Aaron Prime

First Floor Plan

AFHP Design # 280.001 © 2010-2012 Wendy Welfon 603.431.9559		
		Aaron Prime 18 Cushman Greenland Commons, NH
		1
1/4"=1'-0" unless noted otherwise / Print @ 1:1 PDF created on: 3/13/2014, drawn by ACJ	Issued for: Digging Set

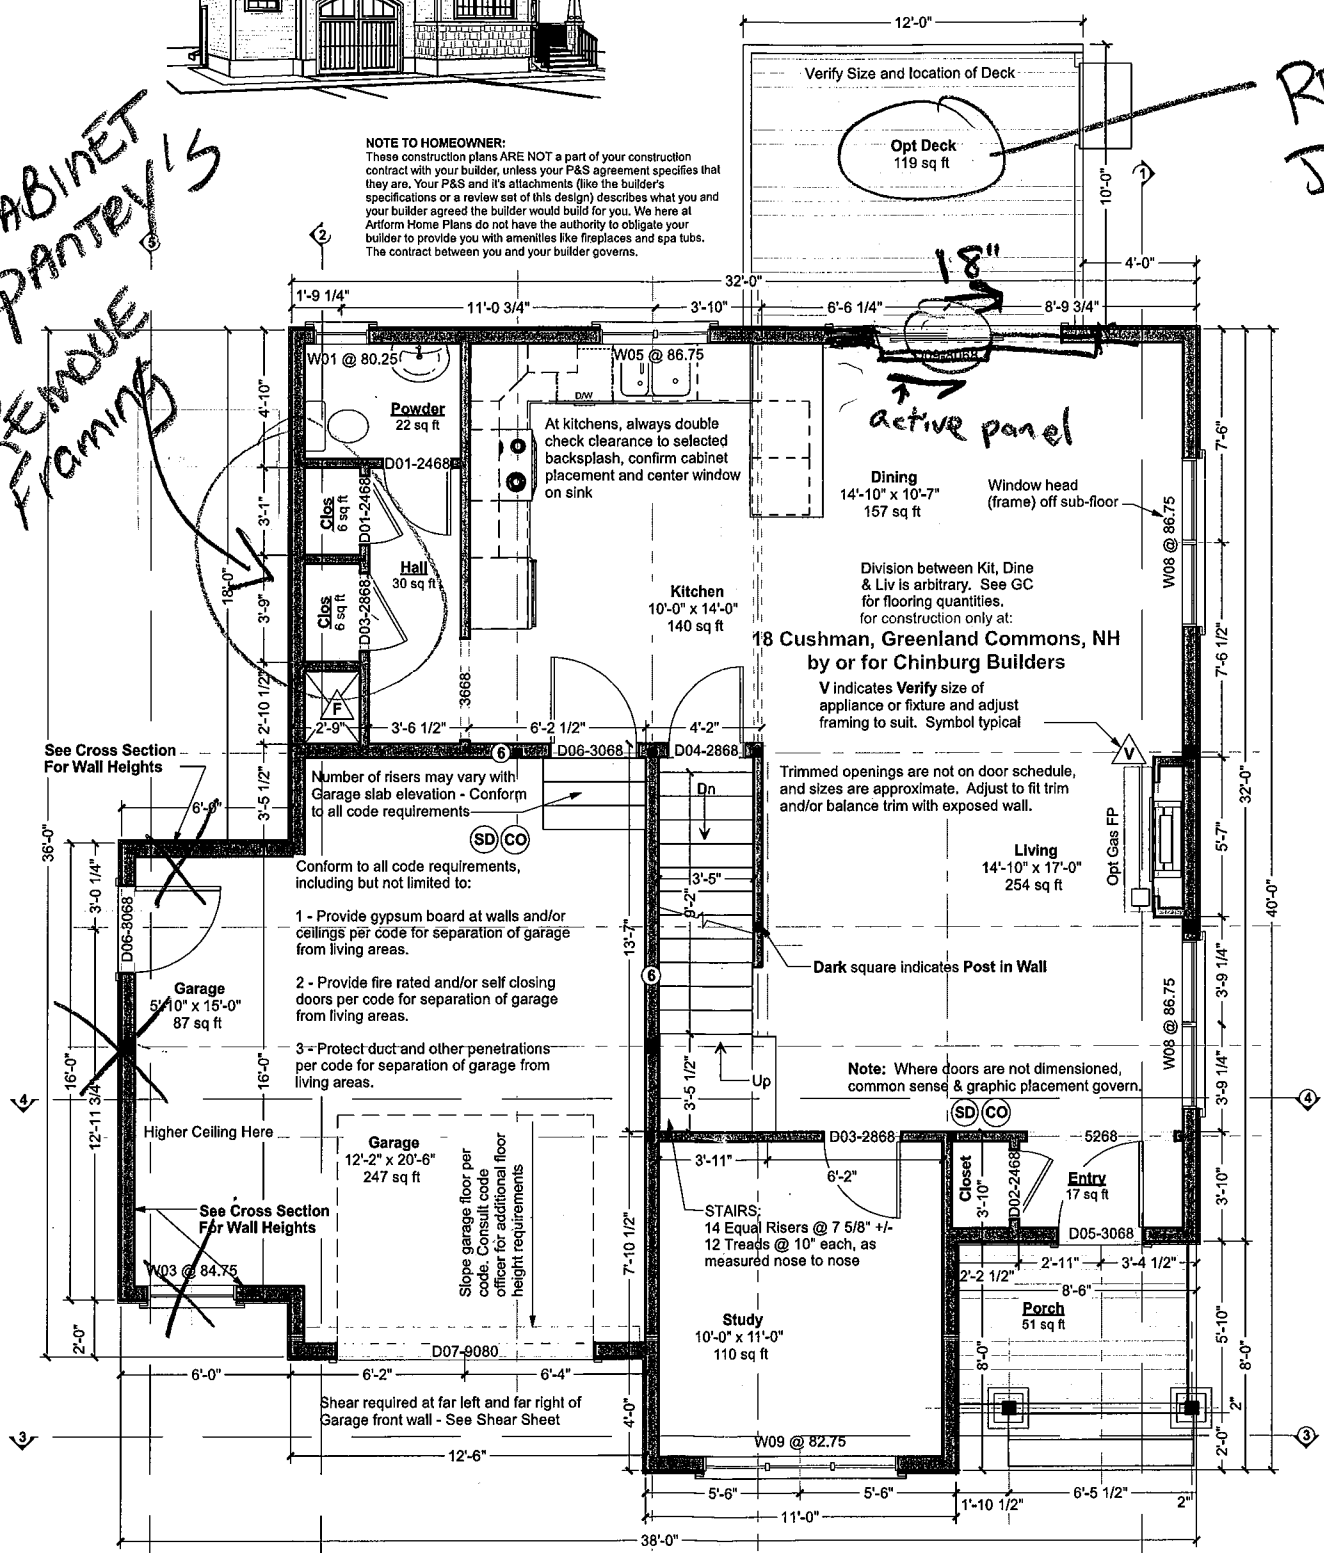
1 Remove Bump
2 NO DECK
3 MB - MISSING
4 10' ceiling in master

CABINET
PANTRY'S
REMOVE
FRAMING

REMOVE
DECK
